IN THE DRAWINGS:

Attached are three (3) Annotated Sheets and three (3) Replacement Sheets. Please substitute original Formal Drawing sheets 2, 3 and 4 with the Replacement Sheets 2, 3 and 4 attached hereto.

REMARKS

FIG. 2

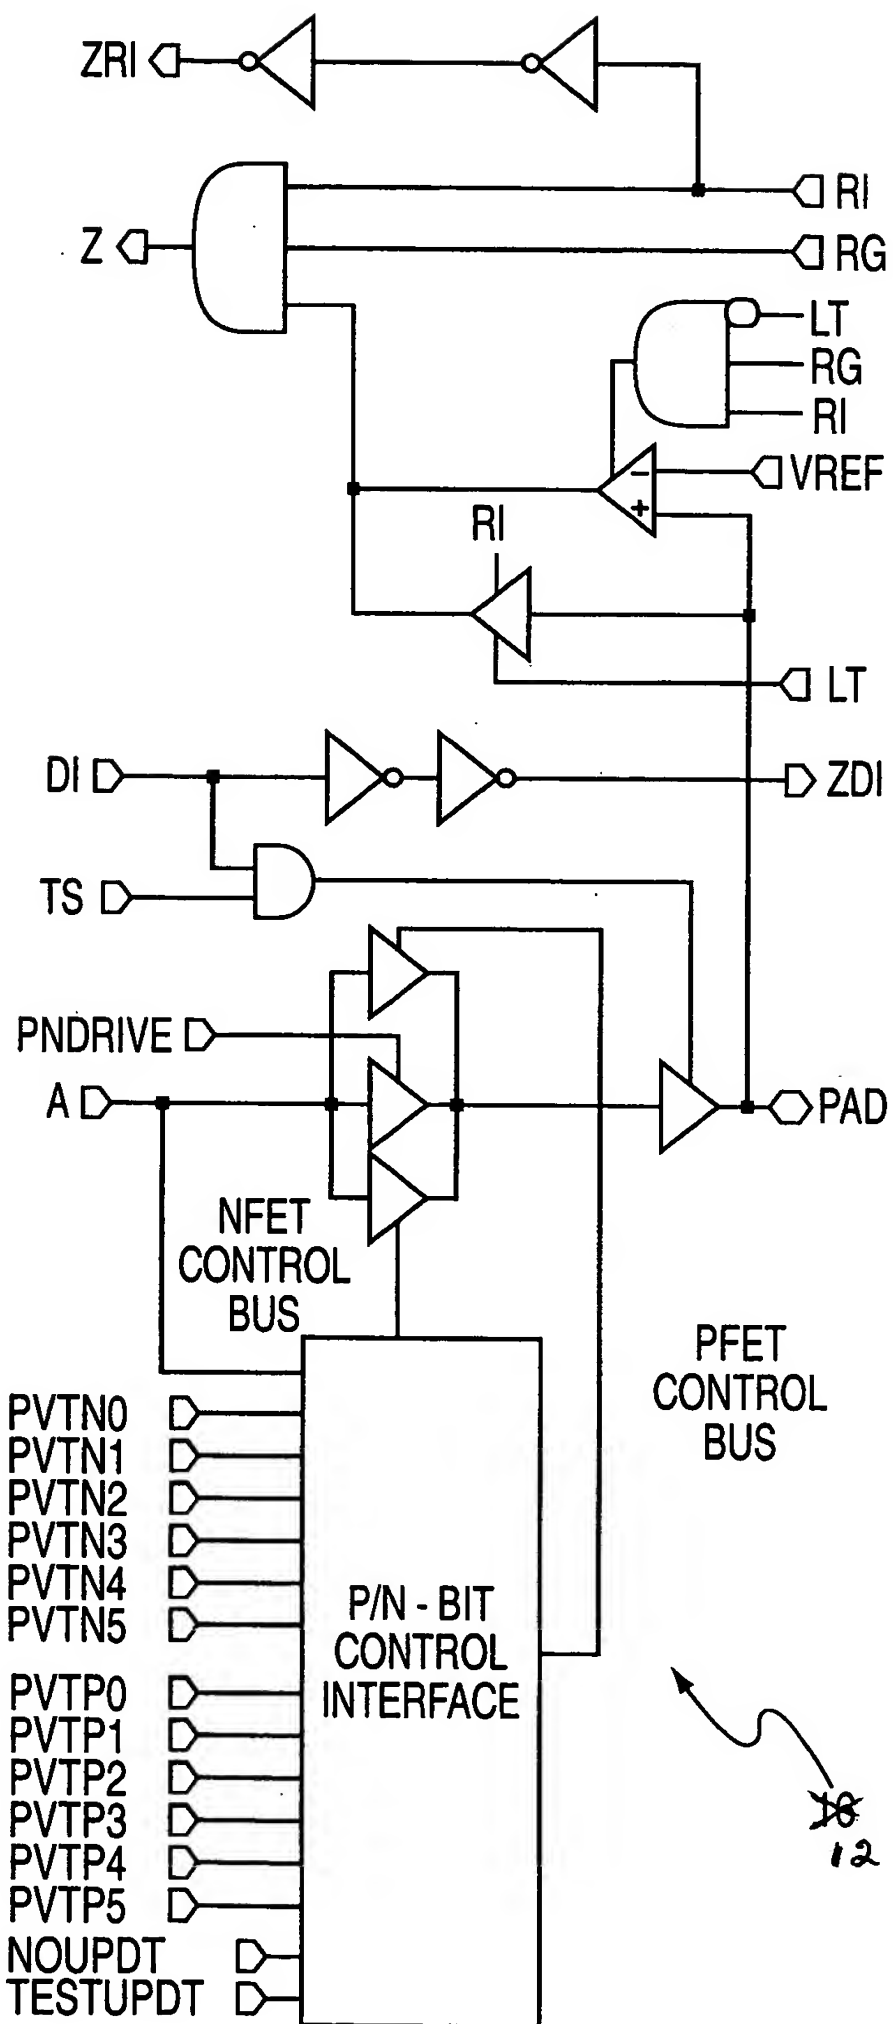
With respect to the drawings, the Examiner, in the Office Action, objected to Applicants' earlier corrections to Figure 2 on the grounds that the changes did not satisfy the requirements for formal drawings. The Examiner suggested making these changes to the formal drawings filed on February 7, 2002. The Examiner also noted that in Figure 3, "16" should be "12" and that in Figure 2B, "PVDRIVE" should be "PNDRIVE".

Replacement sheets showing these corrections to Figures 2A, 2B and 3 are being submitted herewith. Accordingly, the Examiner is asked to reconsider and to withdraw the objections to the drawings.
